August 28, 2017

Re: Water Authority Concerns Regarding the Proposed Plan for Record of Decision (ROD) Amendment for the Fruit Avenue Plume Superfund Site, Albuquerque, NM

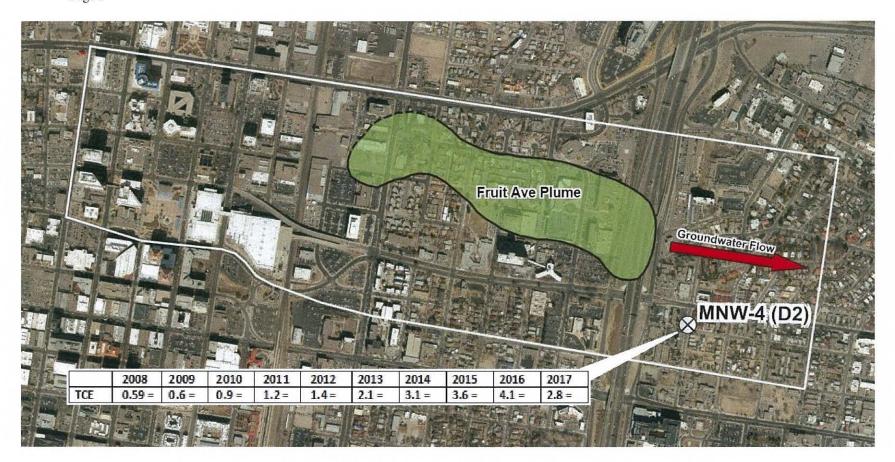
According to the most recent data, the plume (Fig. 1) continues to migrate closer to downgradient drinking water wells at the University of New Mexico and the Water Authority's Yale well field. While the Fruit Avenue Plume is not an immediate threat to the community's drinking water supply, it certainly could become one if natural attenuation fails to perform as hoped. At a minimum, the continued existence of the plume hinders the Water Authority's ability to construct new production wells in the vicinity, which may be necessary as existing wells are taken out of service due to age.
